APPLICABILITY: 2013-15MY BRZ

NUMBER: 12-180-15

SUBJECT: Change to Door Glass Retaining Bolts

DATE: 08-24-15

The illustrations below show both the pre and post-countermeasure glass retaining bolt.

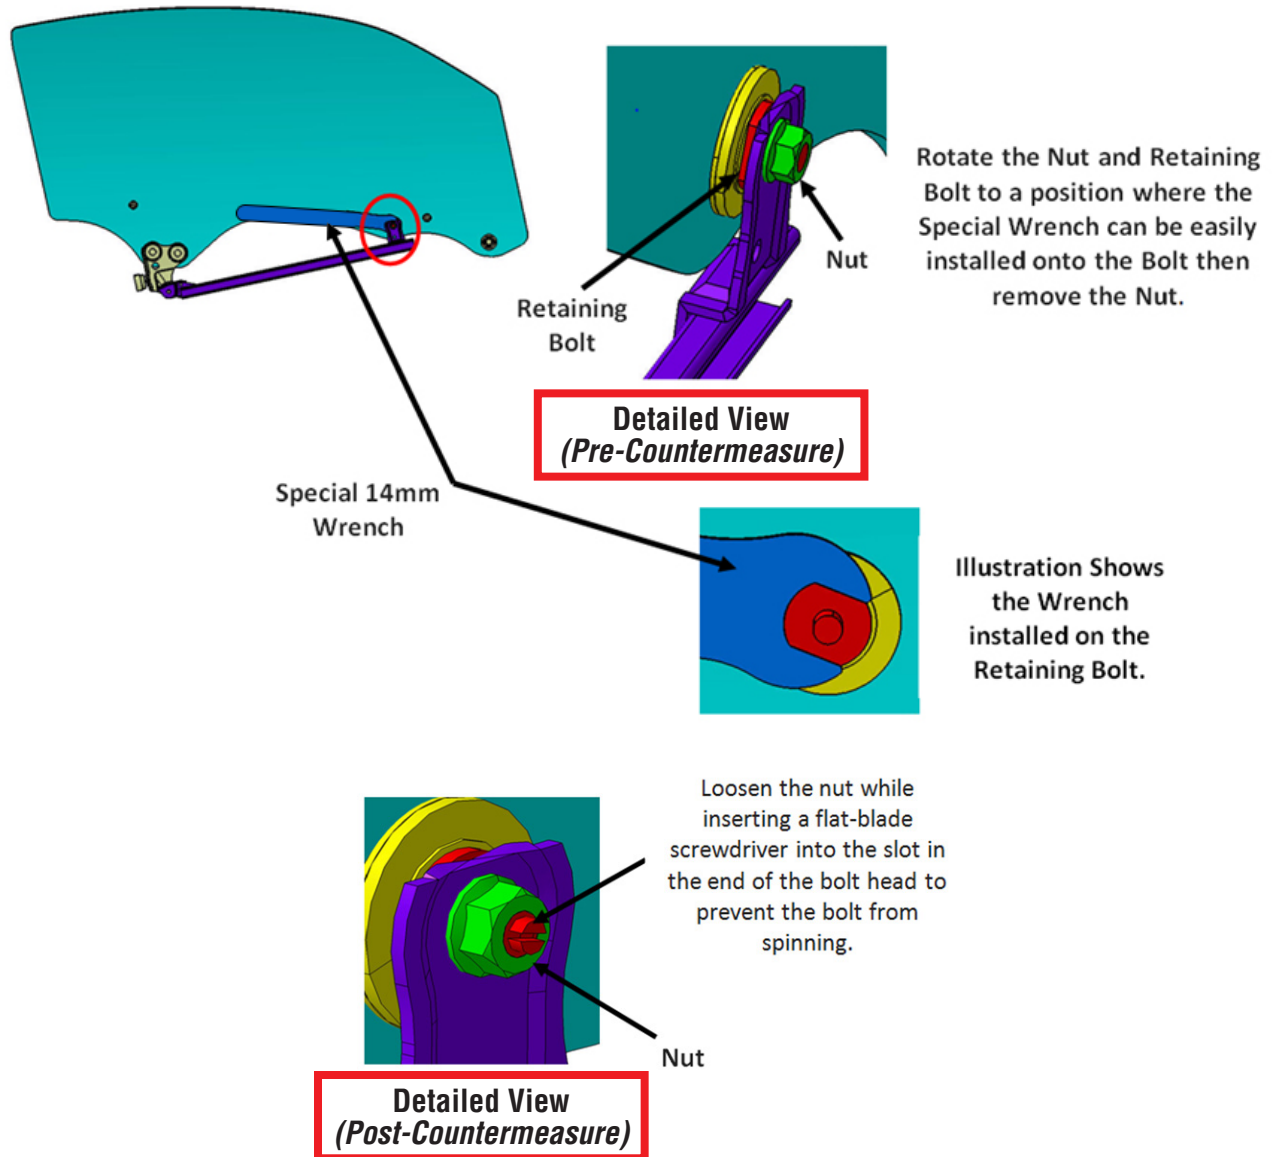
This Service Information bulletin announces a change to the retaining bolt securing the door glass to the window regulator assembly. A slot to accept a flat-blade screw driver has been added to the end of the bolt to keep it from spinning while removing the retaining nut during door glass assembly R&R.

A special, thin (1.8mm) open-end 14mm wrench must be used to keep the glass retaining bolt from spinning while removing the retaining nut. This essential Subaru Special Tool, # SOA321105 will be shipped to each retailer. Replacements or extras can be ordered by accessing the Bosch Service Solutions website: [Subarunet > Service > Special Service Tools](#).
